2130-06-20245
January 9, 2006

Oyster Creek Generating Station
Facility Operating License No. DPR-16
NRC Docket No. 50219

Subject: Response to NRC Request for Additional Information related to
Severe Accident Management Alternatives (SAMA) for
Oyster Creek Generating Station (TAC No. MC7625)

**Response to Request for Additional Information
Regarding Severe Accident Mitigation Alternatives**

Figure 4c-1 Gate Structure Added to Represent SAMA 91

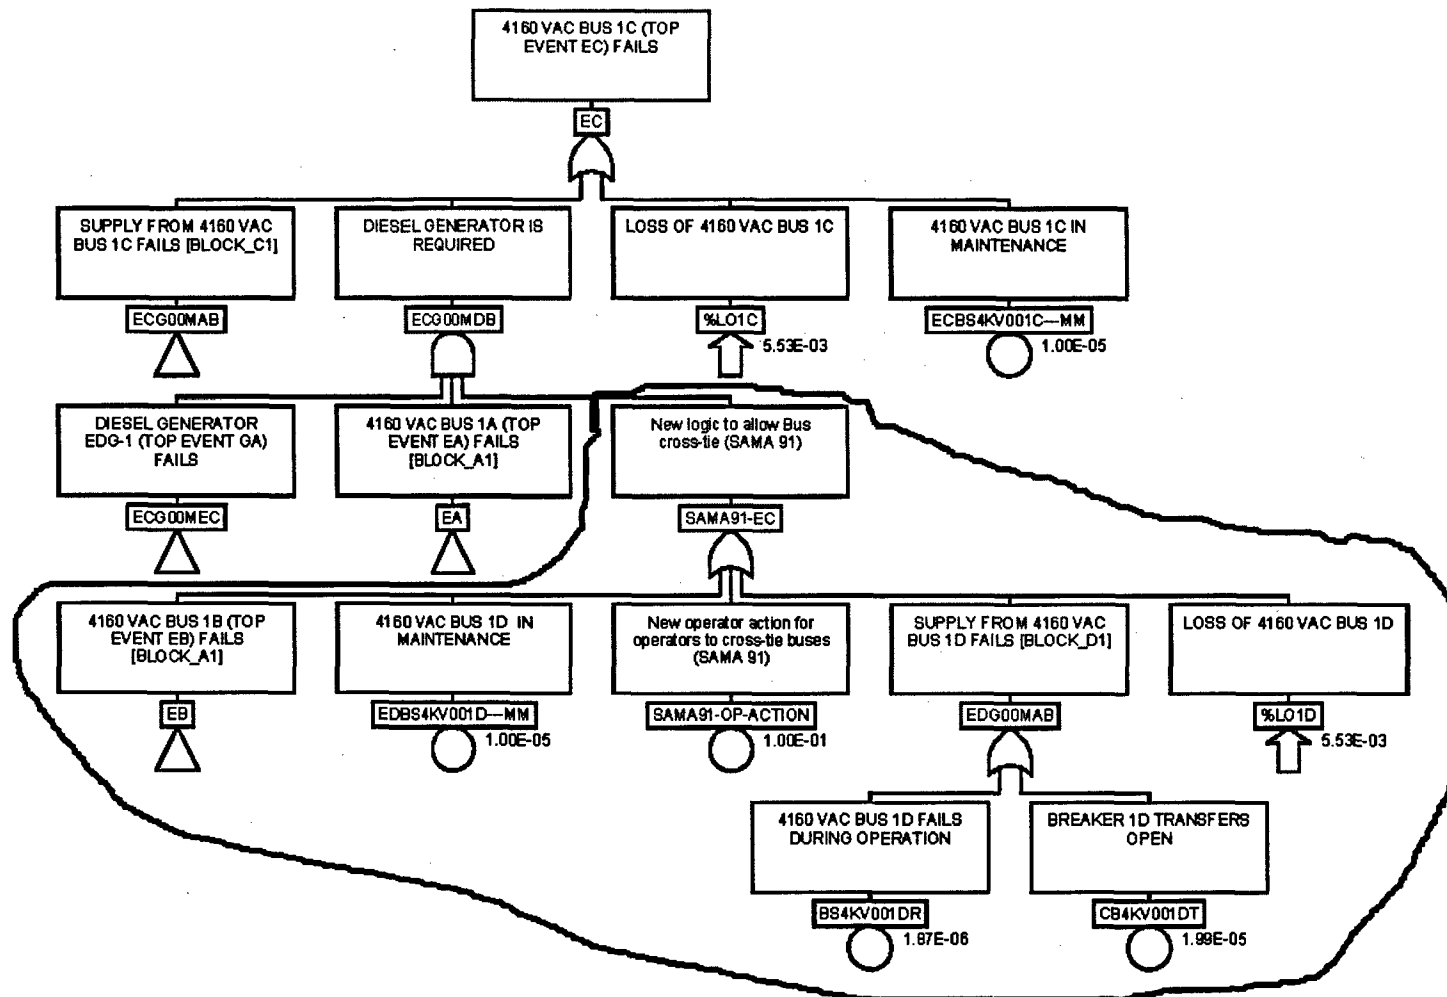
- 4c) The evaluation of SAMA 91 (Section F.6.11) includes a description of modeling the benefit of the SAMA for non-loss of offsite power cases. This description indicates the addition of an "OR" gate that includes opposite division basic events. Clarify how this results in a reduction in CDF.

Figure 4C-1 includes the gate structure added to the base model to incorporate the benefit of SAMA 91 under Gate EC (Safety Related Bus 1C). There is a similar arrangement in the model for gate "ED".

The "OR" gate referenced in the submittal (SAMA 91-EC) groups the opposite train hardware as well as an operator action to perform the proposed cross-tie action as failure modes which could fail the cross-tie function. It is noted that this new gate, SAMA91-EC, is added under the existing "ECG00MDB" gate in order to quantify the benefit of the modification.

Therefore, the failure of the cross-tie is represented by an "AND" of the cross tie with the divisional power supplies (Gate ECG00MDB). Under the "AND" gate, there is the subject "OR" gate.

In summary, the inclusion of the SAMA under the "AND" gate ECG00MDB results in requiring additional failures to fail the gate. This leads to a reduction in the failure probability of Gate EC and the CDF if the SAMA is implemented.
